**WARDTOWN MOBILE HOME COOPERATIVE
PHASE 1 - WATER DISTRIBUTION SYSTEM REPLACEMENT, EAST SIDE
FREEPORT, MAINE**

ADDENDUM #1

DATE: April 16, 2026
TO: PLAN HOLDERS

STANDARD TRENCH NOTES - WATER

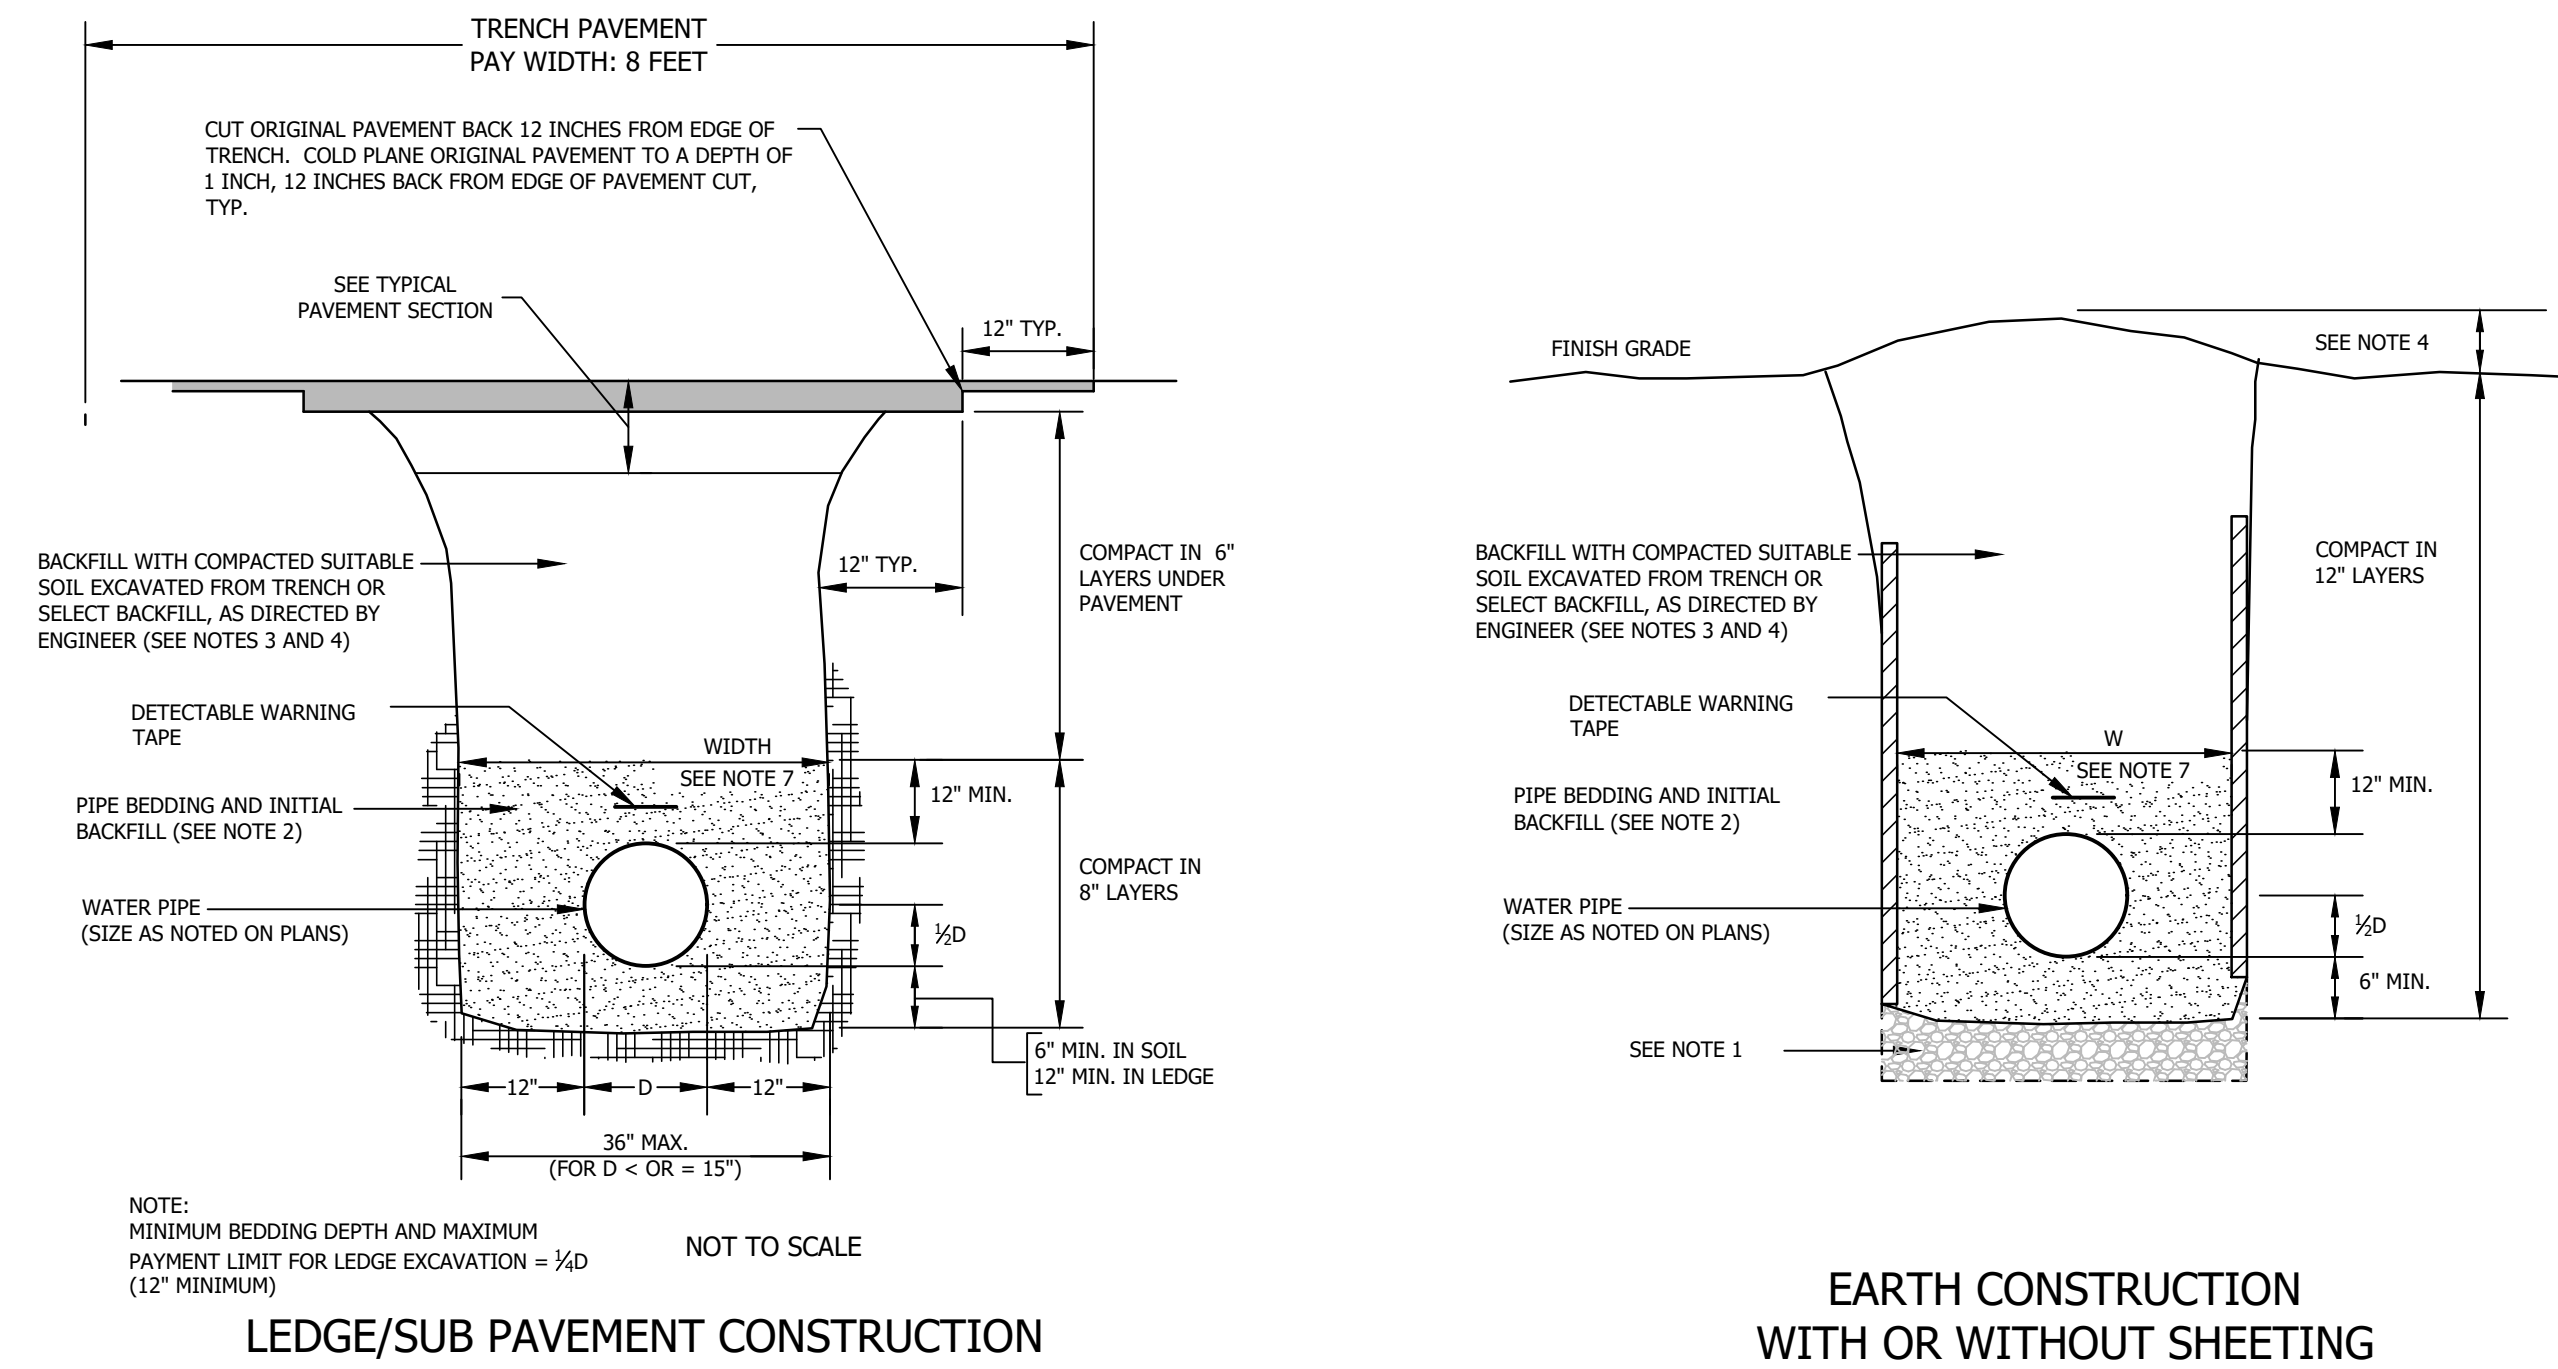
7. Bedding material specified on the site plans shows MDOT "TYPE A". Is this the intended bedding material specification?

The design intent is to provide typical sand material for water main installation. This material shall meet material requirements of Maine DOT specifications 206.02 Construction Methods and 603.04 Bedding. Standard Trench Notes – Water, Sheet C3.2, Note 2 has been revised to reflect this bedding specification.

WATER SERVICE UNDER HOUSE DETAIL

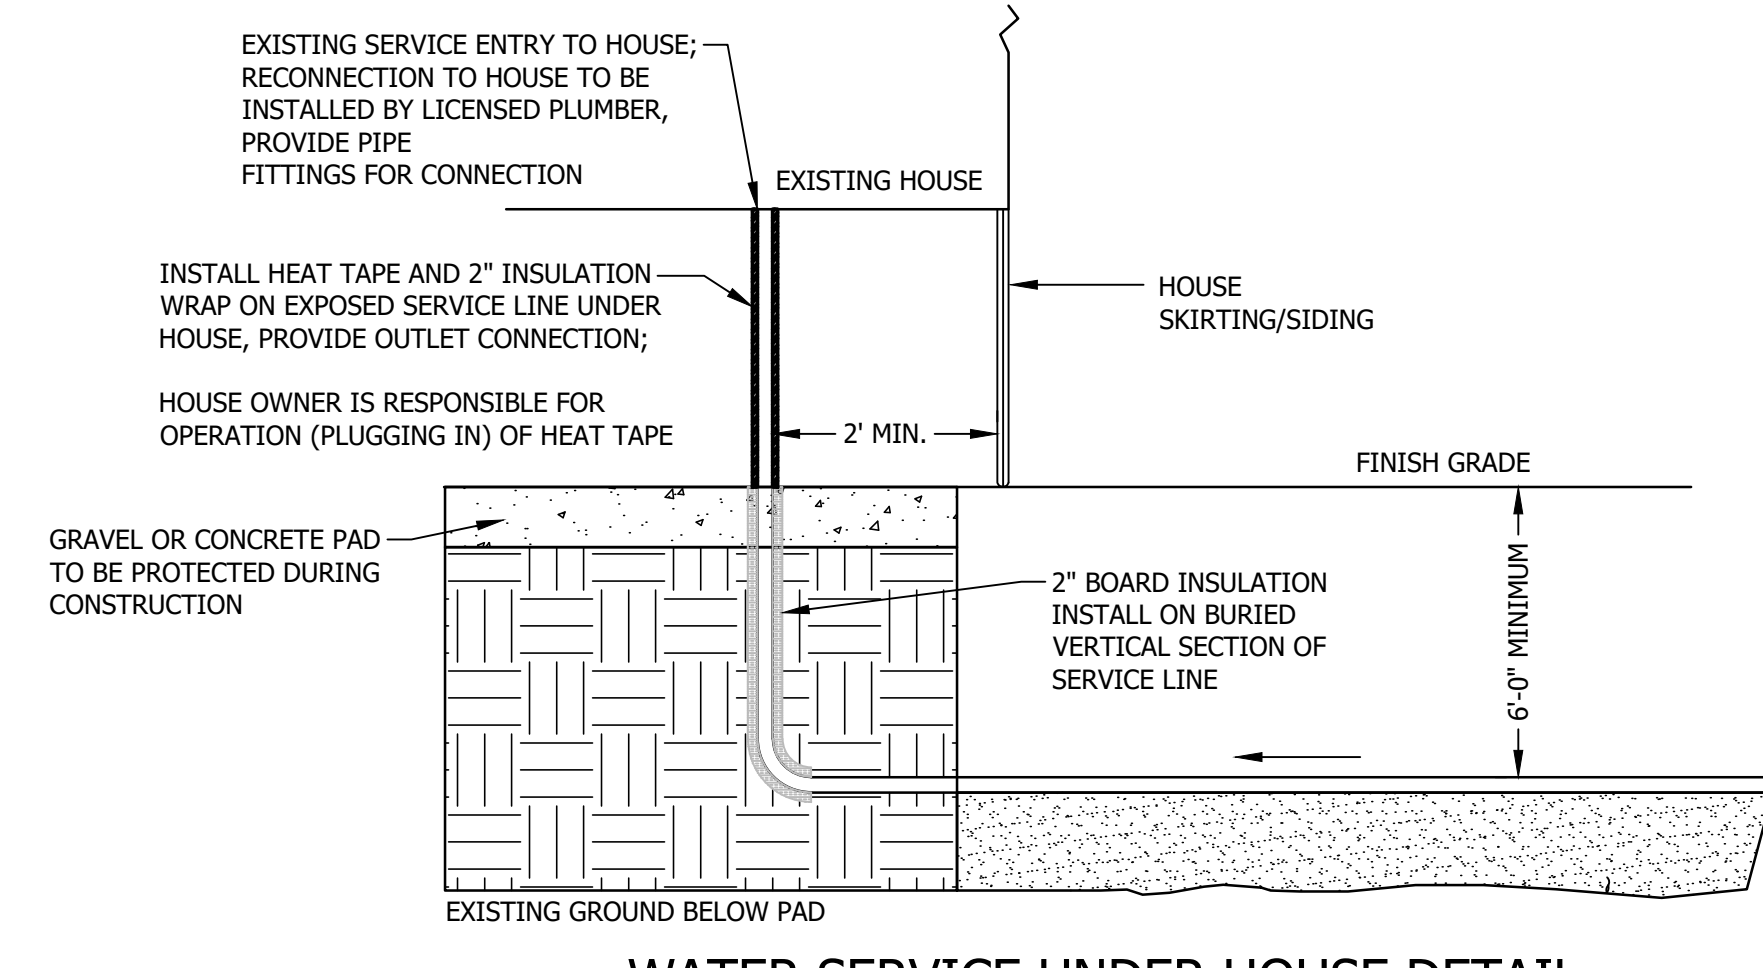
13. Are water services allowed to daylight at the front of each home, then pipe to the existing water connection beneath each home?

Any water services above grade shall be insulated and wrapped with heat tape. See Sheet C3.2, WATER SERVICE UNDER HOUSE DETAIL. The Contractor shall be responsible for the heat tape plug and bringing the plug through the existing home unit flooring. The plug and wiring shall have sufficient length to connect to a power source inside of each home unit. If a power source is found to exist beneath a home unit for the purpose of powering heat tape, the contractor shall plug the new heat tape into the existing outlet beneath the home unit.

The homeowner is responsible for plugging the heat tape connection into an internal power source.
